## DEPARTMENT OF ENVIRONMENTAL QUALITY DIVISION OF RADIATION CONTROL

### MEMORANDUM

SUBJECT: Shallow Aquifer Permeability at Envirocare LARW, 11e.(2) and Mixed Waste Disposal Facility, Clive, Utah.

**ATTACHMENT 3**

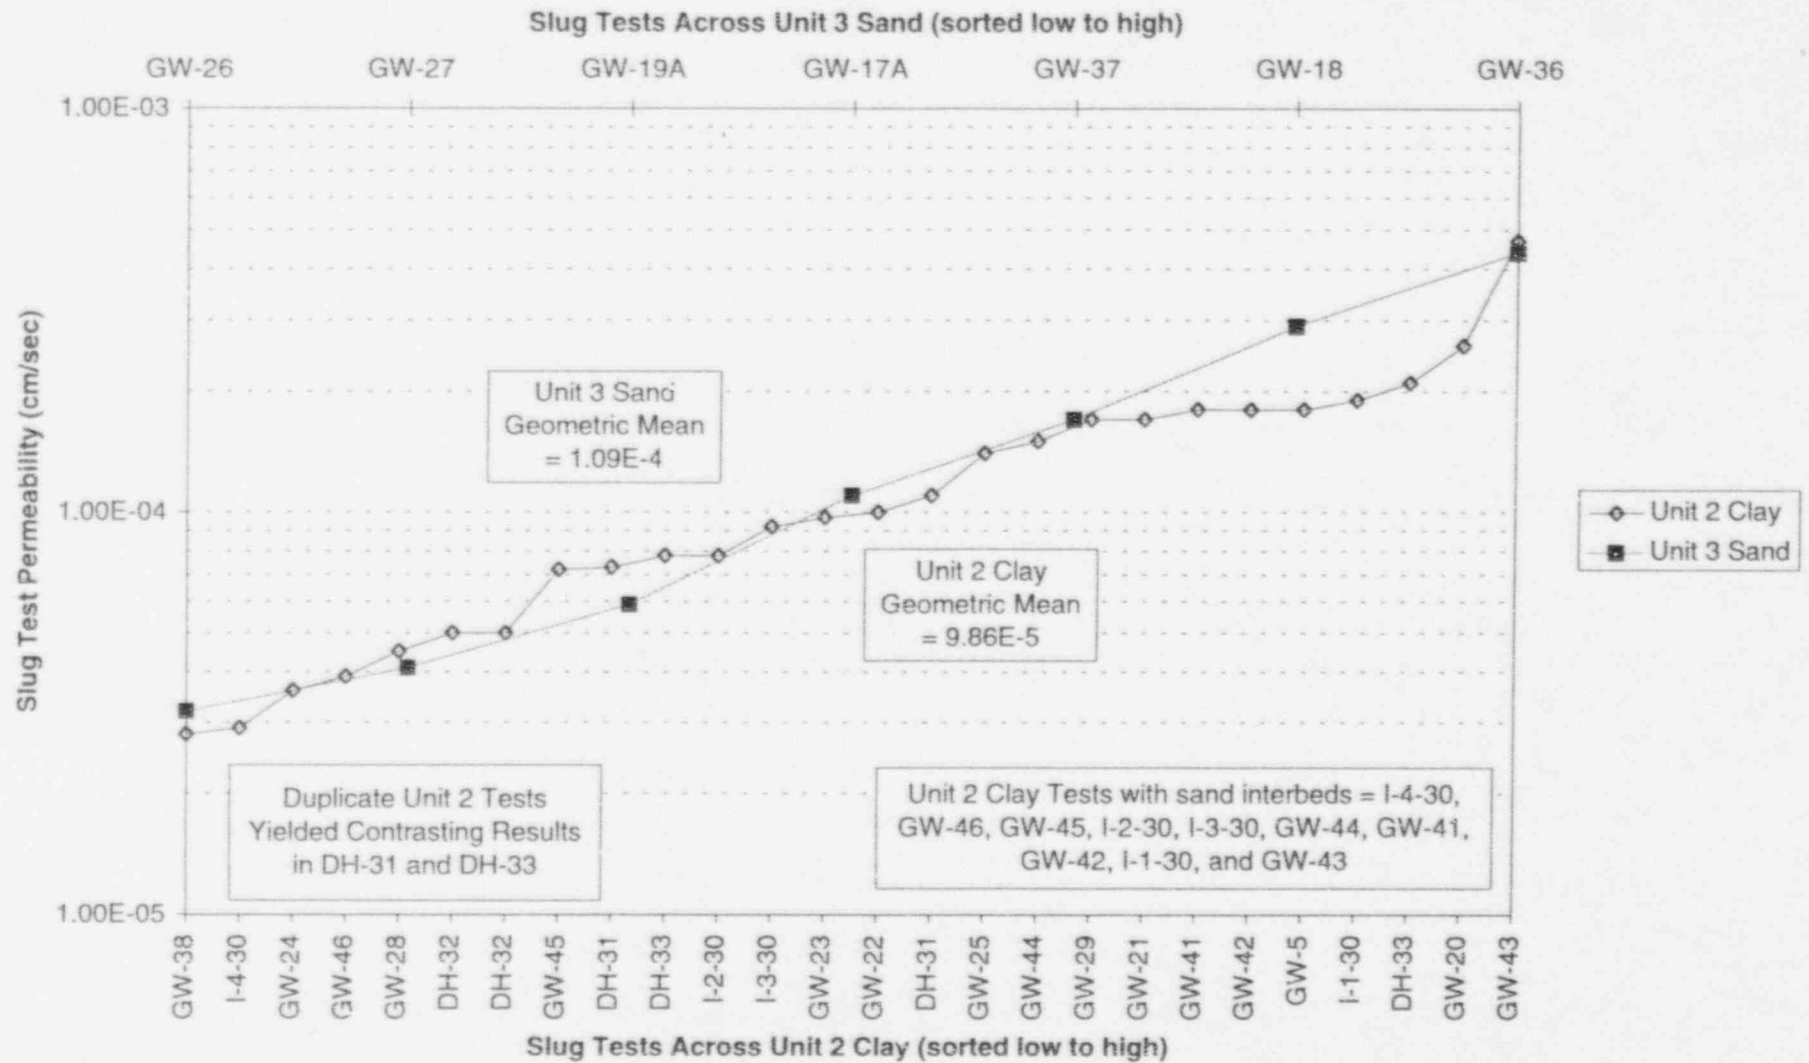
Next, the DRC staff compared the range of slug test permeability results from the Unit 2 Clay and Unit 3 Sand, respectively, see Attachment 3, DRC graph 23SLUG.XLS-2vs3. Comparison of these data clearly show an overlap in range of field permeability, despite the fact that these tests were conducted on distinct and separate hydrostratigraphic units.

The overlap of permeability seen in these two lithologic units may be explained by heterogeneity in each of these stratum. For example, thin sand interbeds have been found in soil logs for the Unit 2 Clay, see wells GW-41, GW-42, GW-43, GW-44, GW-45, GW-46 (November 18, 1994 Bingham Report, Appendix A), and I-1-30, I-2-30, I-3-30, and I-4-30 (January 31, 1992 Bingham Report, Appendix A). These sand interbeds may explain the wide permeability distribution in the Unit 2 Clay, relative to those values seen in the Unit 3 Sand. It is also important to note that the same wells in question range widely across the Unit 2 Clay permeability results available; suggesting that when sand interbeds are present, they may not always contribute to higher permeability, but in fact may be of lower permeability clayey or silty sands.

Conversely, the Unit 3 Sand appears to be just as heterogeneous. Silty clay interbeds were also encountered in wells GW-26, GW-27, and GW-37 (January 31, 1992 Bingham Report, Appendix A). Envirocare permeability data show that these Unit 3 Sand wells with clay interbeds range across the lower 71 percentile (5 of 7 tests) of the slug tests available, see Attachment 3. Review of other well logs also shows mention of gradations of clayey sand, silty sands, and "occasional clay interbeds" in soil units reported to be the Unit 3 Sand (see GW-18 and GW-19A, January 31, 1992 Bingham Report, Appendix A). Such heterogeneity either by low permeability interbeds or by gradations of silts and clays could easily reduce the permeability of the Unit 3 Sand, and thus spread its permeability distribution making it overlapping and comparable to the Unit 2 Clay.

As a result of the apparent heterogeneity in both hydrostratigraphic units and their overlapping ranges of permeability, it appears that no distinction in hydraulic conductivity of the shallow aquifer is warranted on the basis of hydrostratigraphy or lithology alone at the Envirocare facility.

**ATTACHMENT 5**

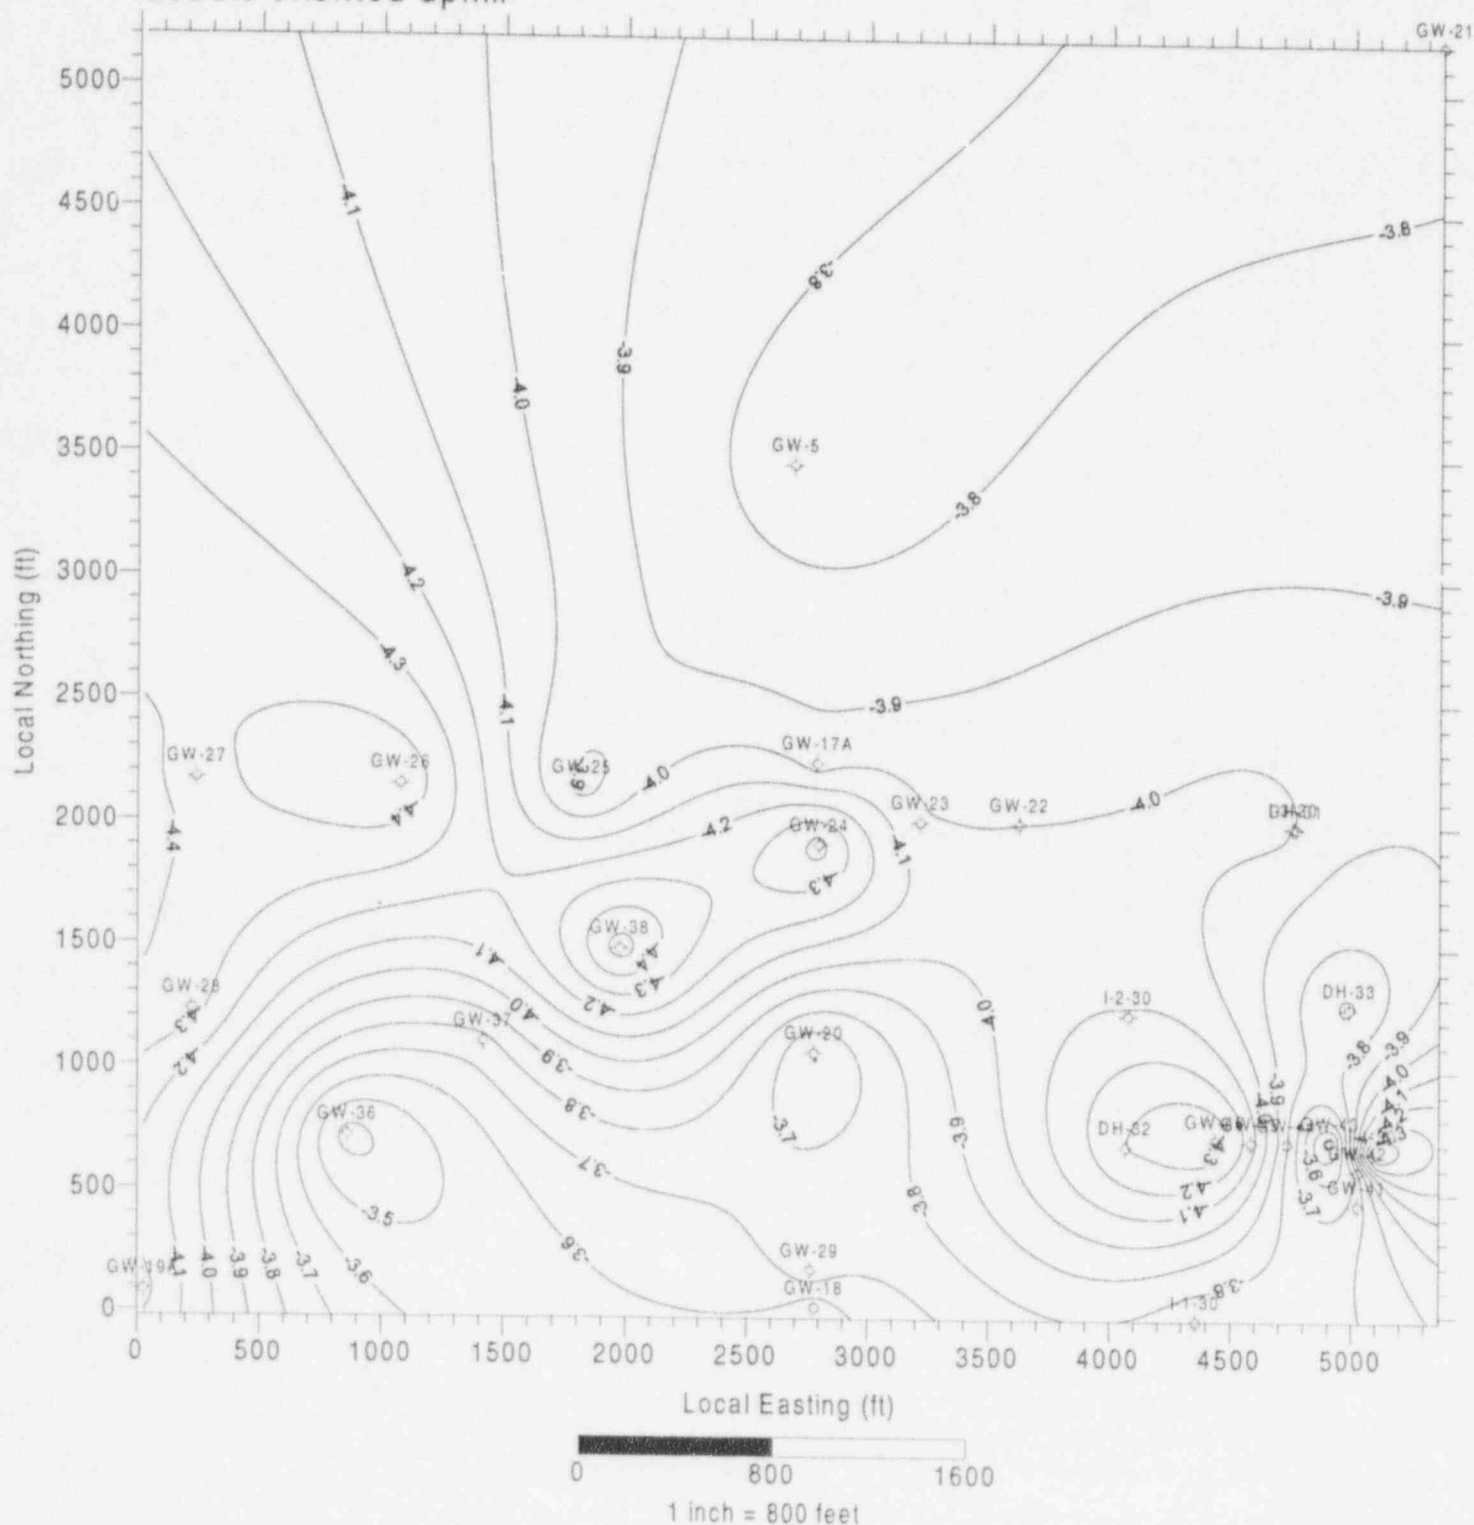
From the DRC permeability contour map, several key observations were made, as follows (see map in Attachment 5):

1. Higher Permeability Trough in Mixed Waste Area - from the available data it is apparent that a north-south trending trough of higher permeability exists in the shallow aquifer between well GW-43 and piezometer DH-33. Such a trend may have significant local effect on ground water flow directions.

2. Higher Permeability Trough Across Vitro Embankment - a northeast striking trough of higher permeability also is apparent between monitoring wells GW-5 and GW-21. However, this spatial trend is based on only two data points, and should therefore be confirmed with the completion of additional wells/piezometers and slug tests before any conclusions are reached for this apparent trend.

3. Low Permeability Ridge Across Facility - an east-west striking ridge of low permeability is apparent between well I-3-30 / piezometer DH-31 found in the north end of the Mixed Waste Area, and well GW-27 near the northwest corner of the 11e.(2) disposal facility. This ridge may also be related to a localized area of low permeability near LARW piezometer DH-32 and Mixed Waste well GW-46. This ridge of low permeability may direct local groundwater flow into other directions, primarily in south, southeast or southwestern directions.

4. Southerly Increasing Trend At LARW and 11e.(2) Disposal Areas - review of the spatial distribution of shallow aquifer permeability suggests a southerly increasing trend away from wells GW-36, GW-37, GW-38 in the 11e.(2) Area, and south away from well GW-20 and piezometer DH-32 in the LARW Area. This general increase in permeability to the south may have significant effect on local groundwater flow directions, and should be investigated further with the installation of additional wells/piezometers and completion of slug tests.

As a result, the spatial distribution of shallow aquifer permeability presented in the contour map in Attachment 5, below, should be considered the best case possible for Envirocare, in that: 1) higher horizontal permeabilities are possible in the field than those measured by the slug tests, and 2) small discrete zones of preferred groundwater flow may exist at the facility which have gone unmeasured by the slug test data, and hence are not represented on the DRC permeability contour map.

ATTACHMENT 6

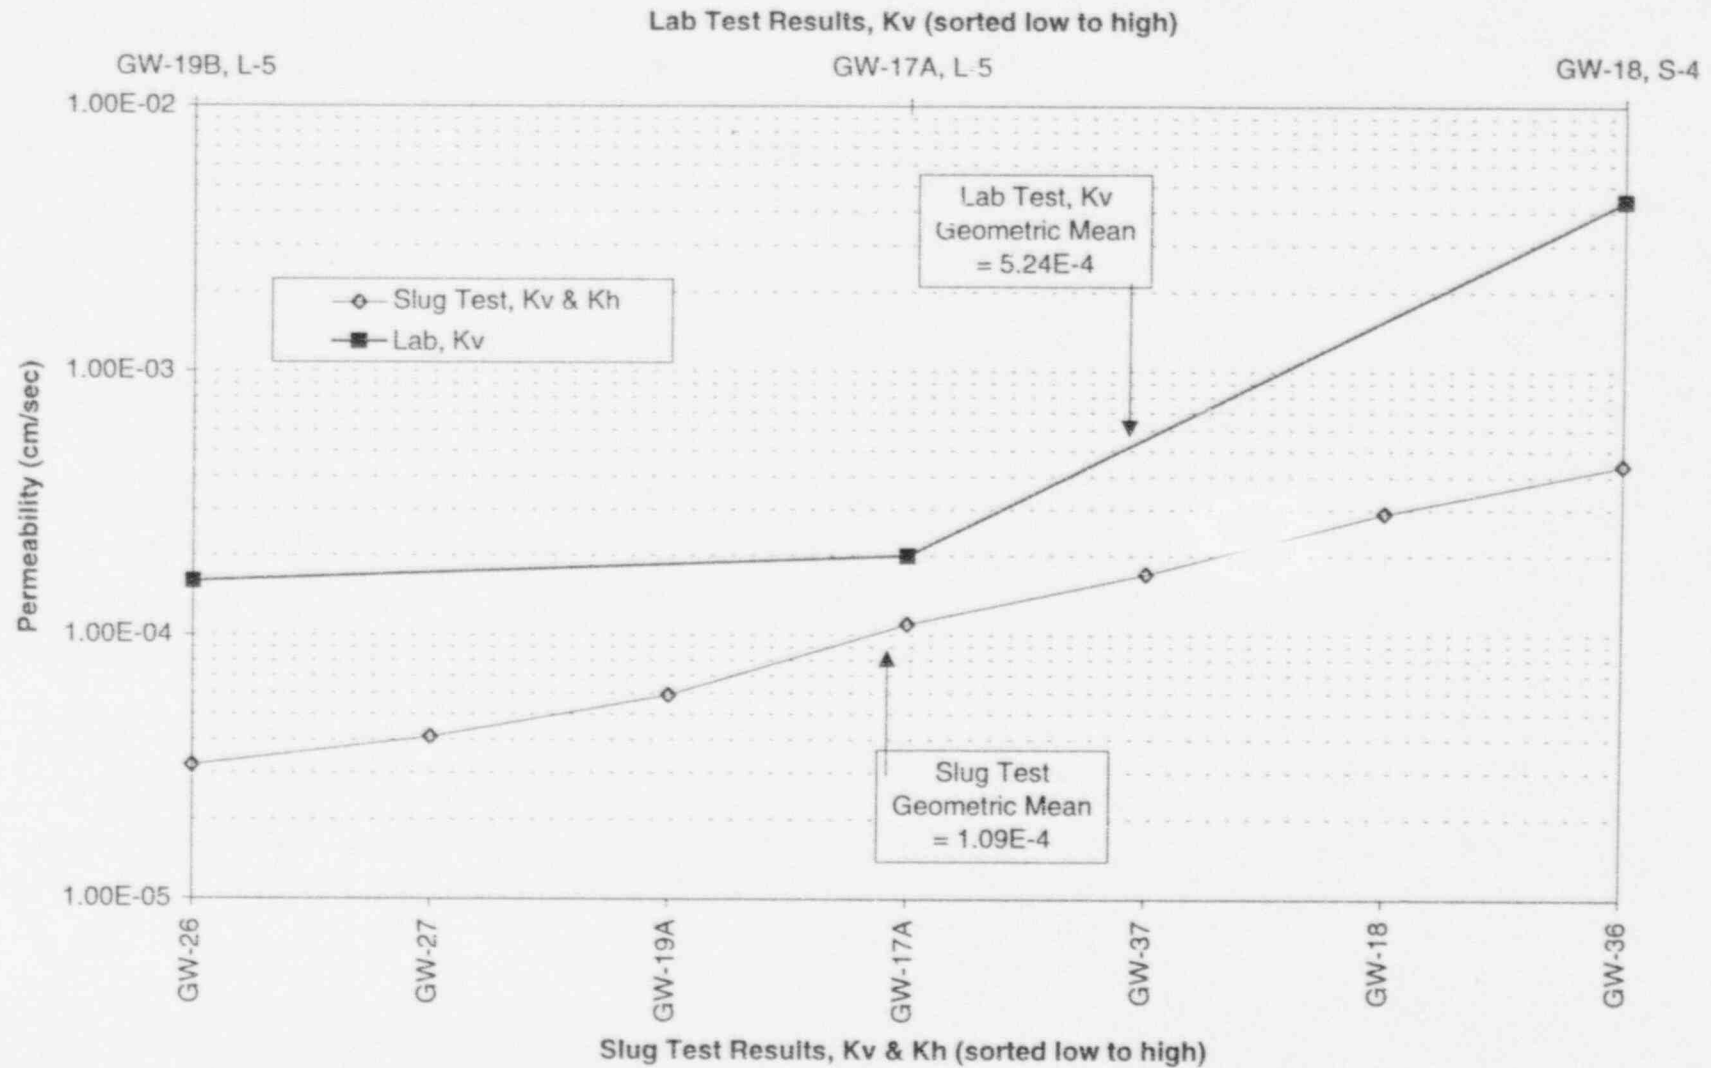
1. Higher Vertical Permeability in Unit 3 Sand - review of available core data shows vertical permeability, in all cases, was greater than the slug test values produced from the Unit 3 Sand, see Attachments 1 and 6, below. Although limited laboratory data are available, this relationship may have been caused by one or more of the following factors:
  - A. Core Sample Bias - wherein Envirocare biased selection of coarser Unit 3 Sand samples selected for laboratory testing, or

- B. Permeability Reduction by Field Heterogeneity - in that clay interbeds and gradations of silts and clays in the Unit 3 Sand reduced effective field permeability measured by the slug tests.

Because Envirocare has not yet tested horizontal permeability exclusive of any vertical components, and in light of the higher vertical permeabilities seen in the core samples, there exists the possibility that discrete zones of higher horizontal permeability could exist in the shallow aquifer which could provide preferential zones for contaminant transport.
